1970 Corvette: Service Bulletin: Water Pump Bearing and/or Shaft Failures

Bulletin No: 71-T-37

Date: June 23, 1971

FIGURE-1

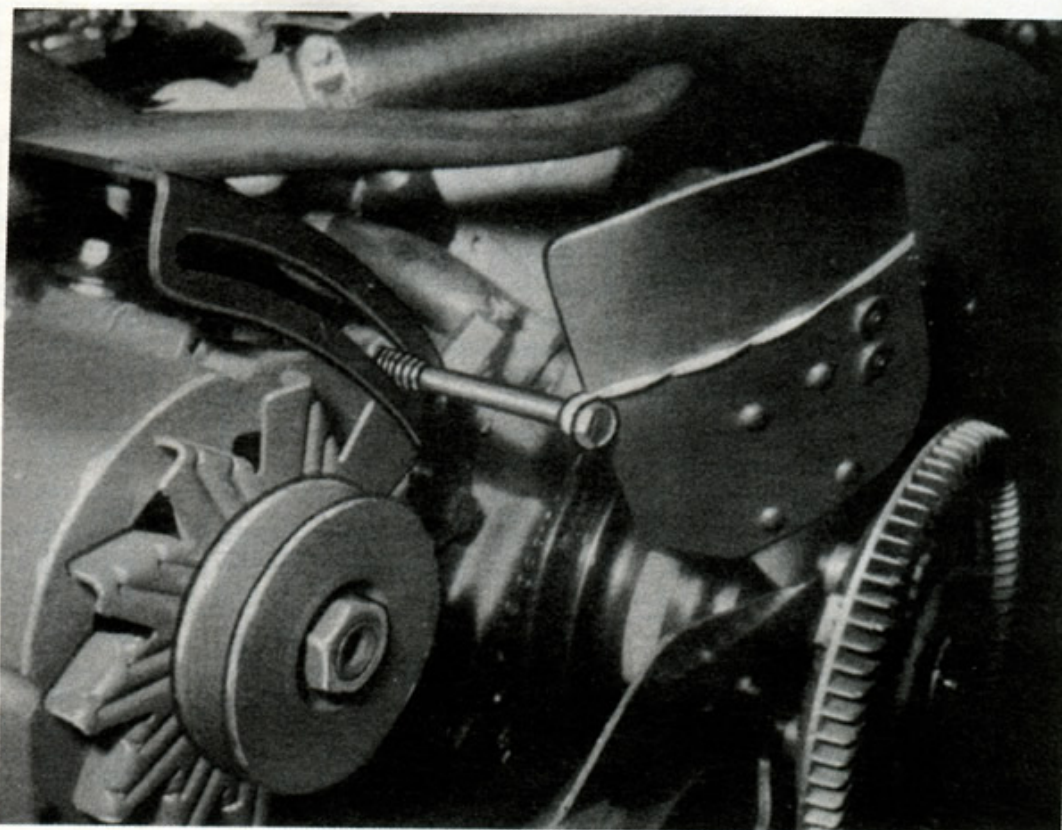
- A. Secure the fan blade to prevent rotation. (See Figure 1).
- B. Mount a dial indicator (.001 graduations) to the engine and place the indicator pointer on the fan blade spider. Preferably on the longest

FIGURE-2

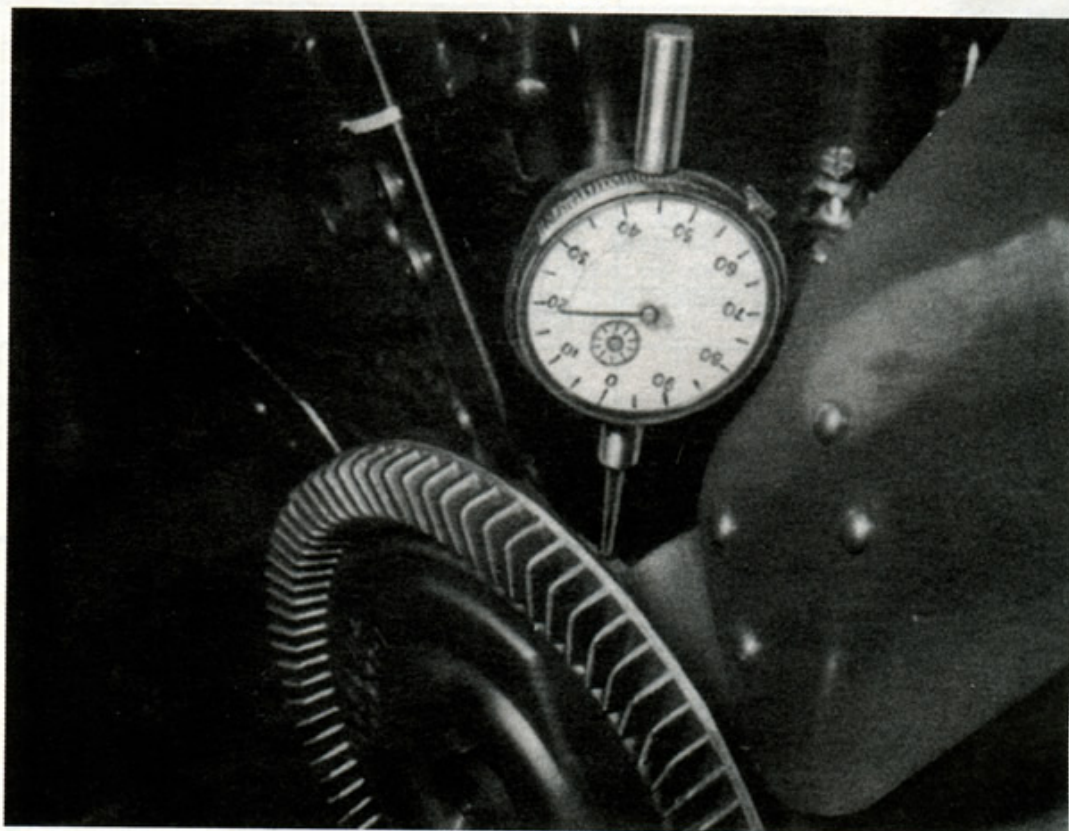
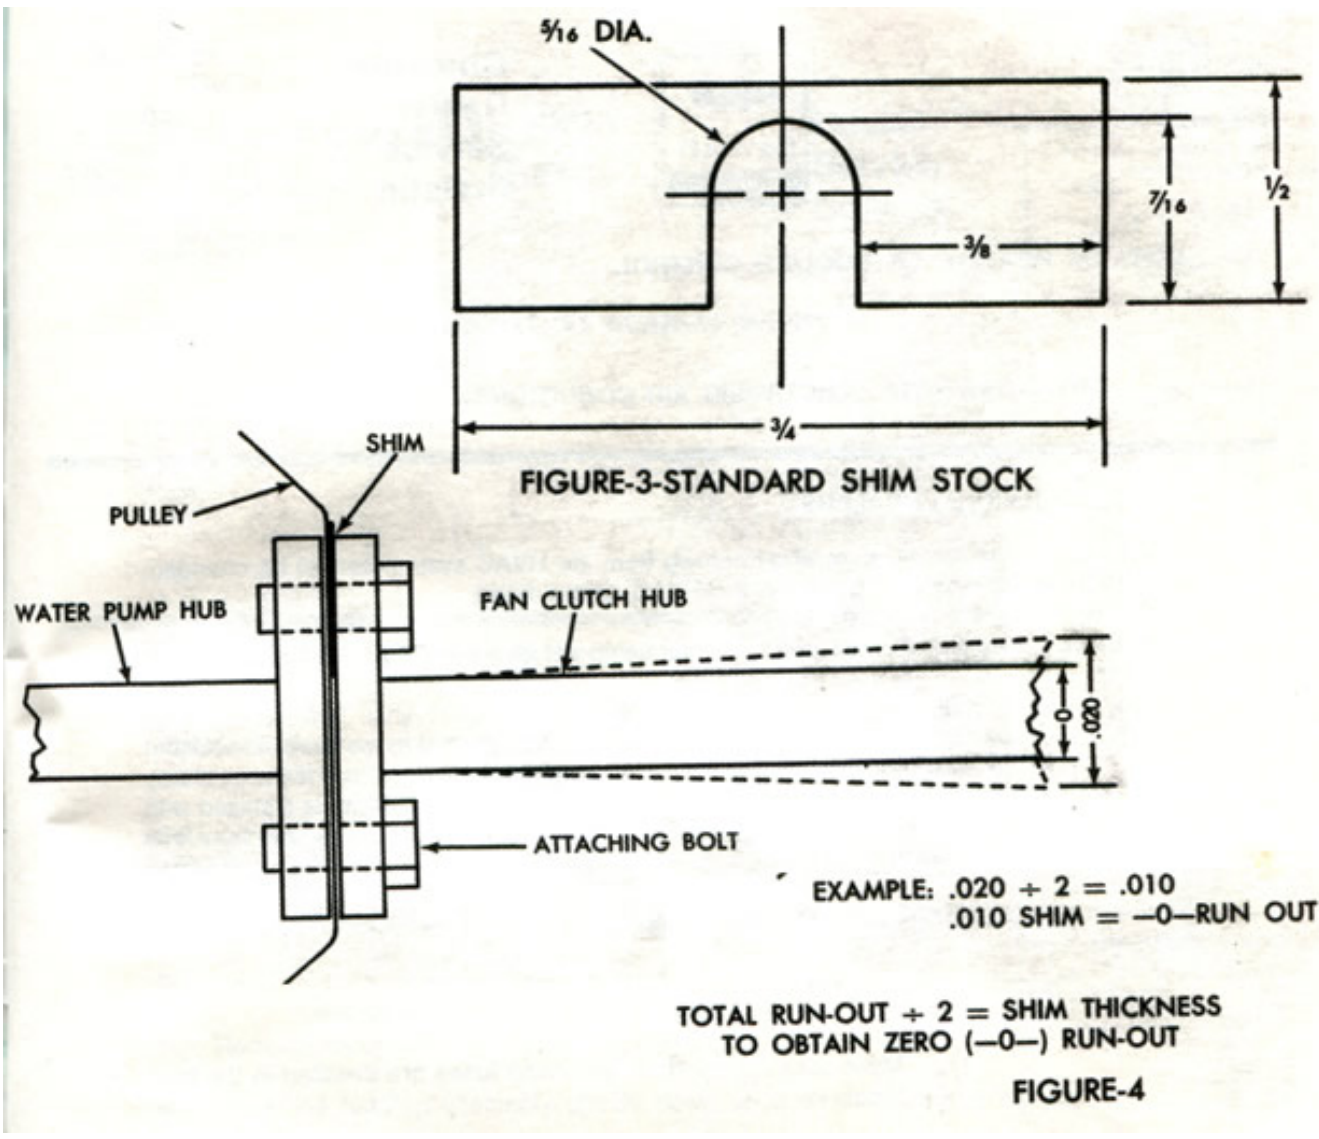
- band or space on the spider. (See Figure 2).
- C. Rotate the water pump pulley in one direction and note the total amount of indicator needle movement. This represents the total radial run-out. Mark the point on the pulley at which the highest reading is obtained.
